SUBJECT: Beaver Valley Power Station - Unit No. 2  
Docket No. 50-412  
Significant Deficiency Report 82-04  
"Westinghouse Solid State Protection System"

Report on Significant Deficiency 82-04  
"Westinghouse Solid State Protection System"

Subject		Number
<b>POTENTIAL UNDETECTABLE FAILURE-ONLINE TEST SWITCH</b>		NSD-TB-84-01
System(s)		Date
<b>SOLID STATE PROTECTION SYSTEM</b>		MARCH 20, 1984
Affected Plants	AFFECTS SAFETY RELATED EQUIPMENT	S.O.(s)
<b>SEE ATTACHMENT III</b>	YES <input checked="" type="checkbox"/> NO <input type="checkbox"/>	387
References	Sheet <u>1</u> Of <u>7</u>	
<b>SRC-ID-82-194 CHANGE CONTROL NO 6156</b>

OUTPUT RELAY TEST CIRCUIT  
STANDARD 2-TRAIN SSPS

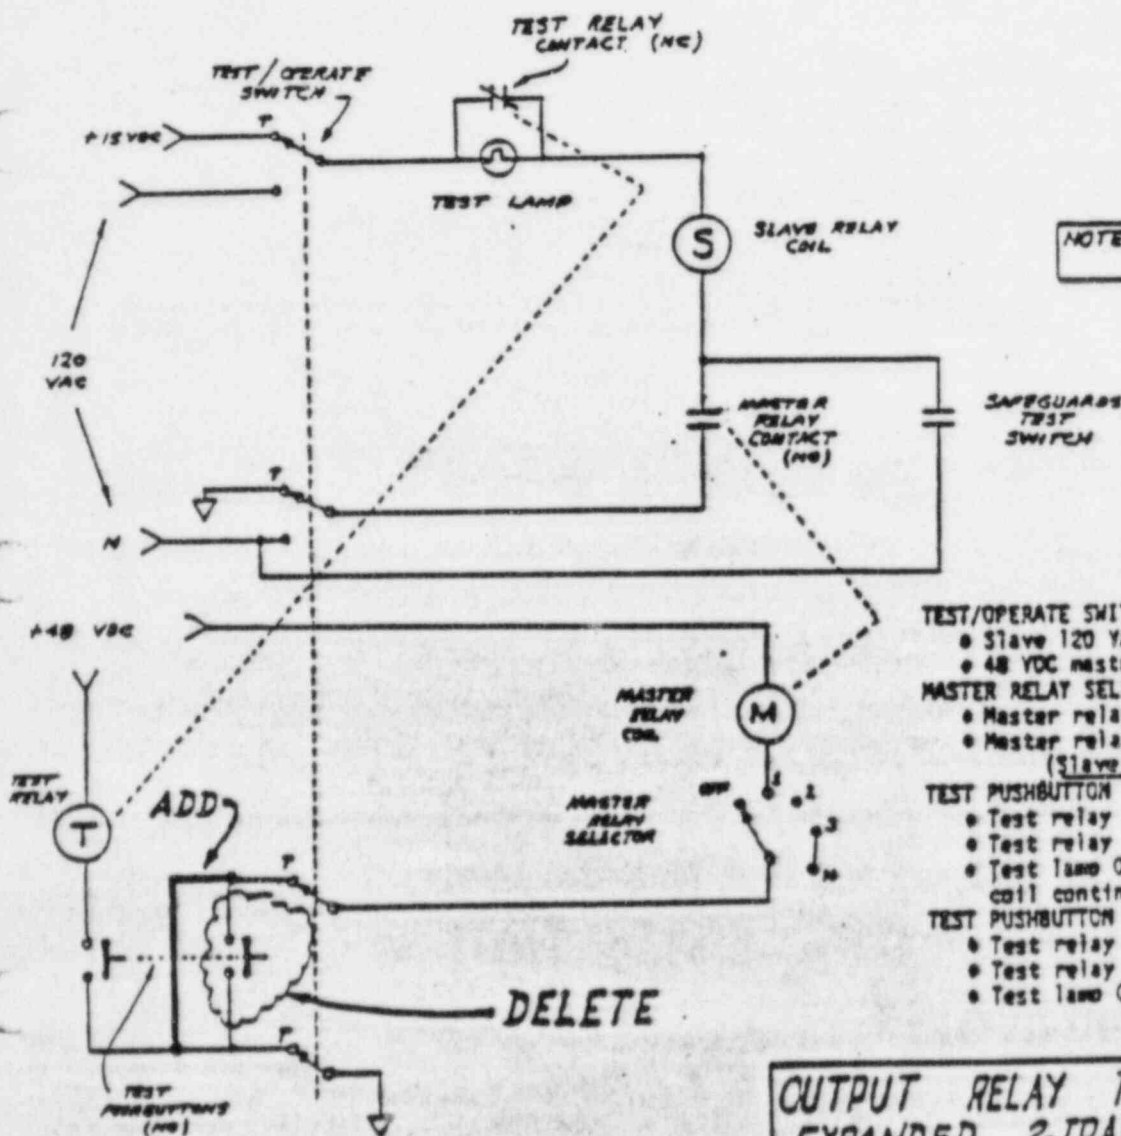
- TEST/OPERATE SWITCH TO TEST
- Slave 120 VAC reduced to 15 VDC
  - 48 VDC master relay ground returned
- MASTER RELAY SELECTOR SWITCH TO RELAY BEING TESTED:
- Master relay energizes
  - Master relay contacts close 15 VDC to slave (Slave not energized on 15 VDC)
- TEST PUSHBUTTON DEPRESSED
- Test lamp ON confirms circuit and slave relay coil continuity.
- TEST PUSHBUTTON RELEASED
- Test lamp OFF confirms test lamp shunted

OUTPUT RELAY TEST CIRCUIT  
EXPANDED 2-TRAIN SSPS

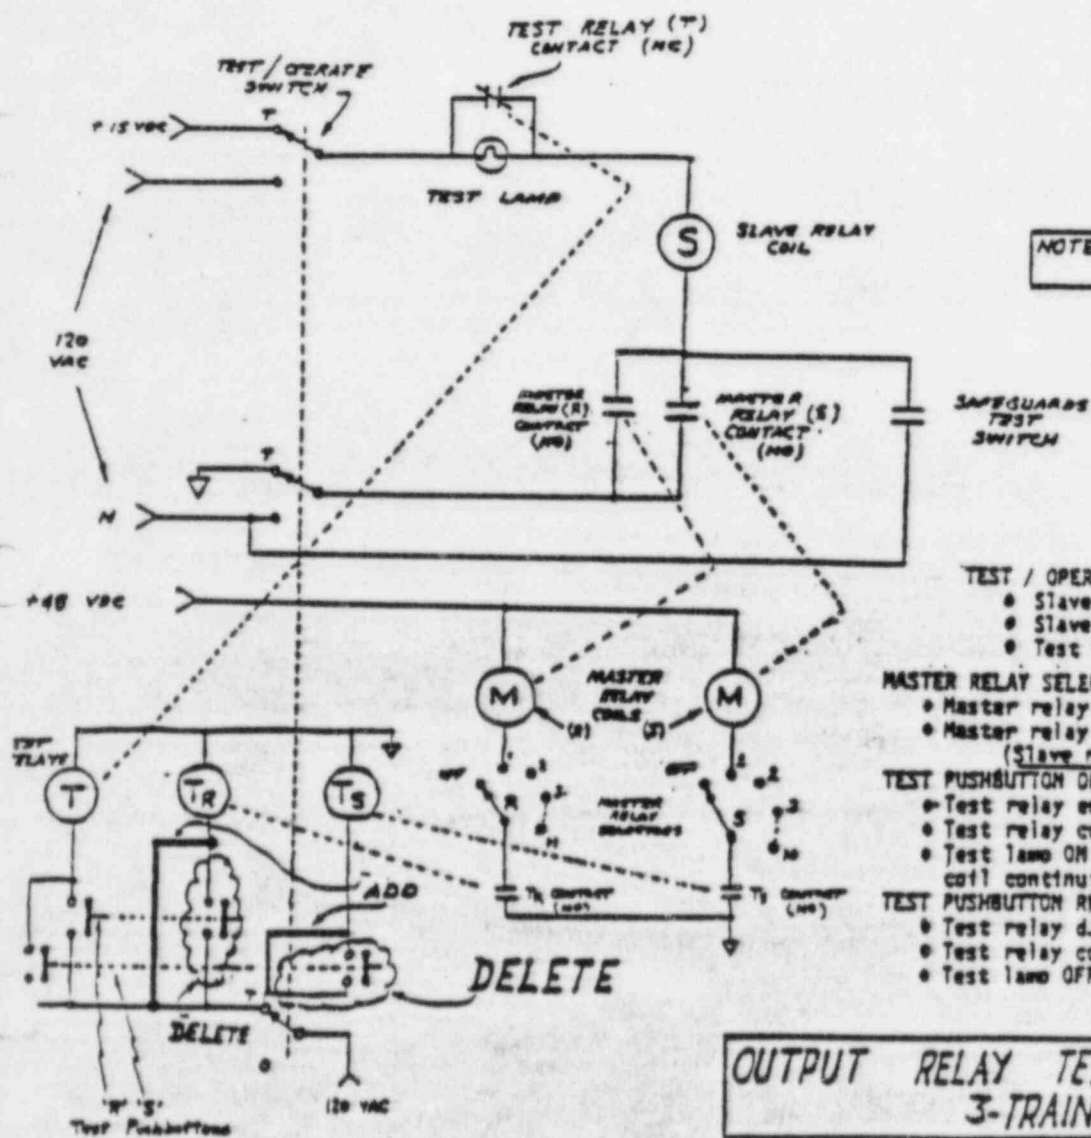
TEST / OPERATE SWITCH TO TEST

- Slave 120 VAC reduced to 15 VDC
- Slave relays ground returned
- Test relays  $T_6$  &  $T_8$  energized

MASTER RELAY SELECTOR SWITCH TO RELAY BEING TESTED

- Master relay energizes
- Master relay contacts close 15 VDC to slave  
(Slave not energized on 15 VDC)

TEST PUSHBUTTON DEPRESSED

- Test relay energizes
- Test relay contacts open
- Test lamp ON confirms circuit and slave relay coil continuity

TEST PUSHBUTTON RELEASED

- Test relay dj-energized
- Test relay contacts close
- Test lamp OFF confirms test lamp shunted
